MODEL 710 SHORT ACTION

NEW PARTS

M710 Short Action Status

MAGAZINE BOX

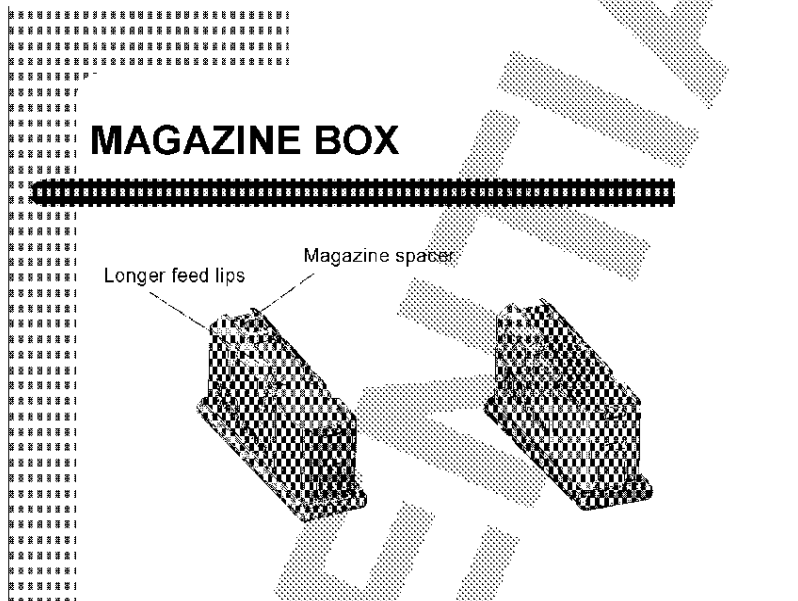
Short action requires new magazine box,
magazine follower, magazine box bottom,
and magazine spacer.

INSERT FOR M/700 FIRECONTROL

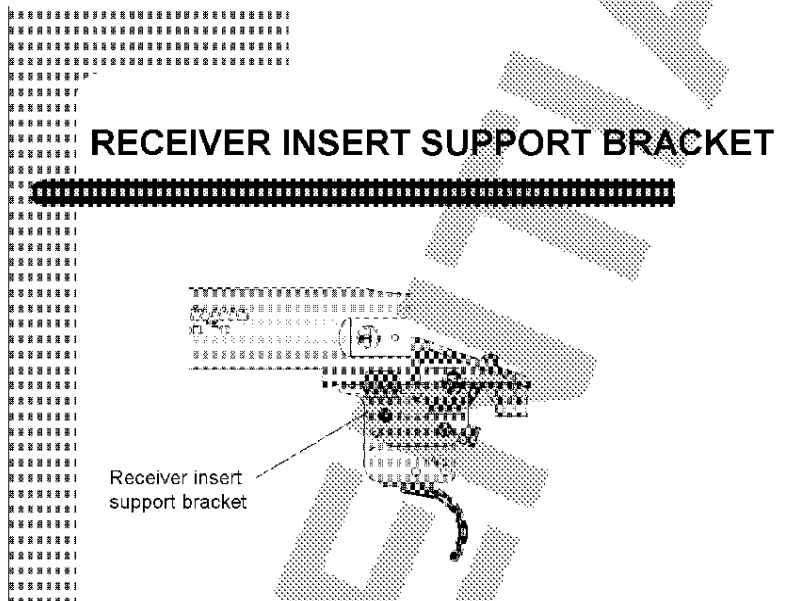
Receiver insert with
M/700 SPL firecontrol

New receiver insert

Model 700 SPL fire control

STOCK MODIFICATION FOR M/700 FC

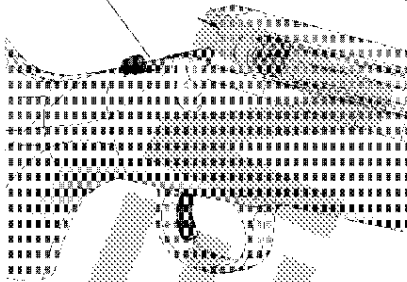
Clearance for safety button

STOCK MODIFICATION FOR M/700 FC

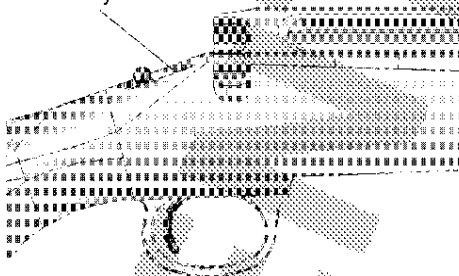
Clearance for safety button
